29 January 2016

**RE: Staged State Significant Development Application for UTS Blackfriars
Precinct Research Building (SSD 6746), 2-14 Buckland Street, Chippendale**

ATTACHMENT A - URBAN DESIGN SITE PRINCIPLES

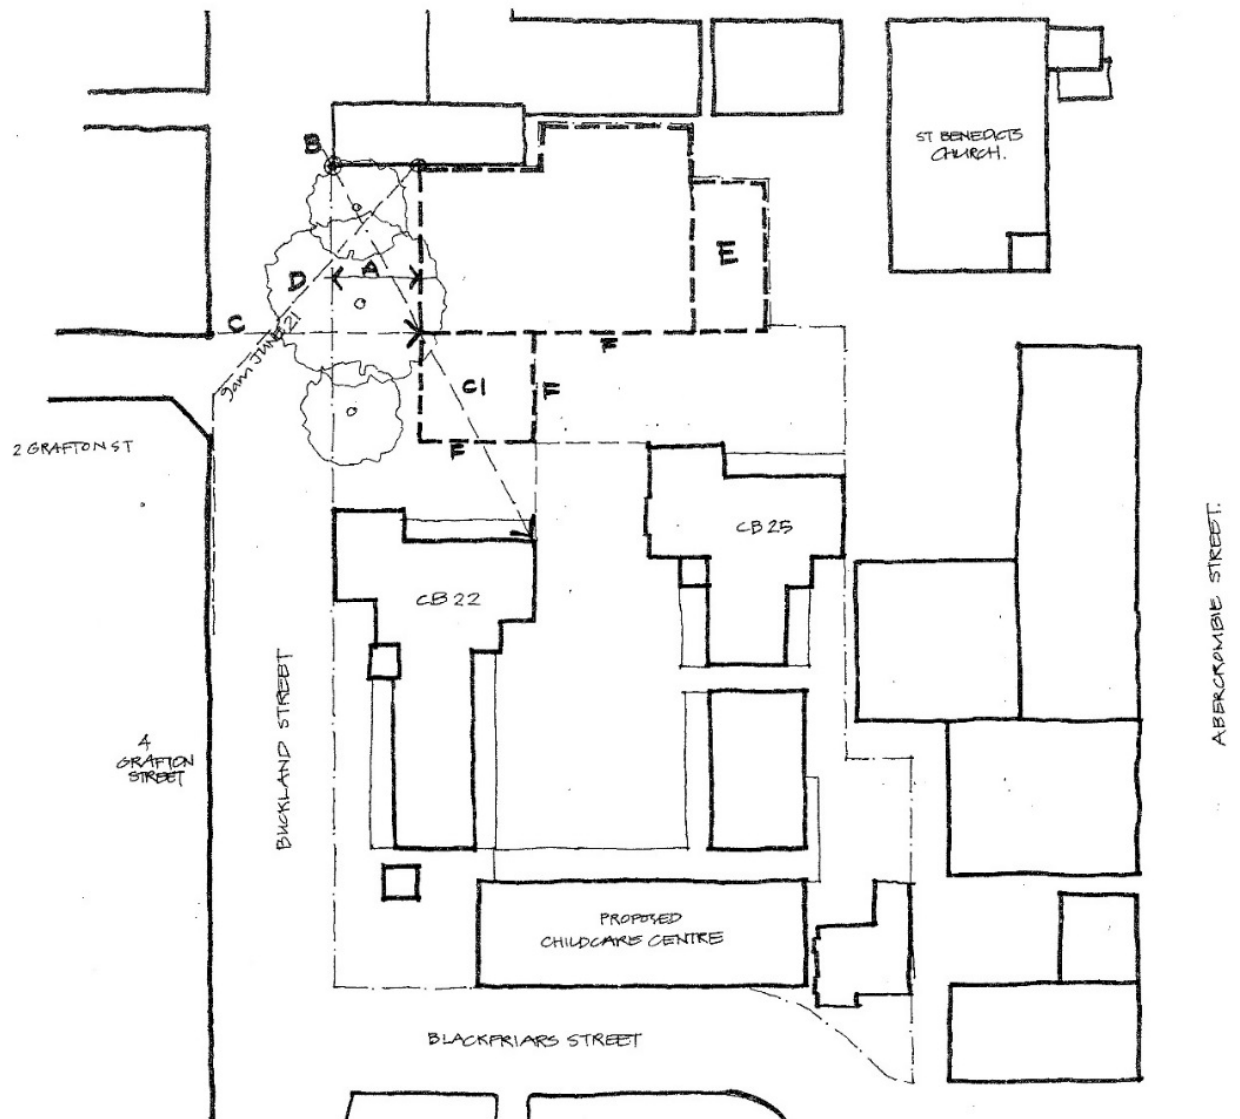
- The building height along the eastern property boundary adjoining the UNDA campus should be no higher than 2 storeys if it is built directly on the eastern boundary (refer notation **E** in **Attachment A**). Any storeys above 2 storeys should be set back from the site boundary. The extent of setback is to be proportional to the additional height and subject to the new buildings visual impact on the UNDA campus, in particular on the church hall and its spire. The new building should not appear in the backdrop of the spire of the church building at the key vantage points from surrounding streets.

- The envelope should be modified through the creation of a setback to the Buckland Street frontage to allow the protection of the trees numbered T33, T34 and T35 and the retention of the heritage palisade fence. The width of the setback from the Buckland Street frontage should be determined as at least the minimum recommended by a qualified Arborist for the protection of the trees (refer notation **A** in **Attachment A**).

- The setback from the western site boundary should retain and reinforce views from the public domain to the north face of Building CB22 (refer notation **B** in **Attachment A**).

- The northern alignment of the historical extent of Grafton Street should be used to determine a portion of the alignment of the south face of the proposed building envelope (refer notation **C** in **Attachment A**). The alignment can be interpreted through the use of a transparent facade if desired (refer notation **C1** in **Attachment A**).

- The building envelope should be modified to remove any impact of overshadowing on existing residential dwellings. The modifications proposed above in relation to the significant landscape items will assist in reducing overshadowing impact to 2-4 Grafton Street (refer notation **D** in **Attachment A**).
- The envelope should be modified so that the portion of the site adjacent to the northeast site boundary is limited to 2 storeys in height (refer notation **E** in **Attachment A**).
- Plant and building services should be located in the basement to allow the maximum amount of above ground envelope to be utilised for research/educational uses.

- The building envelope should be modified so as to be parallel or perpendicular to the existing heritage buildings. Steps in the building envelope or future building footprint should relate to the existing courtyard typology and respect historic alignments (refer notation **F** in **Attachment A**).
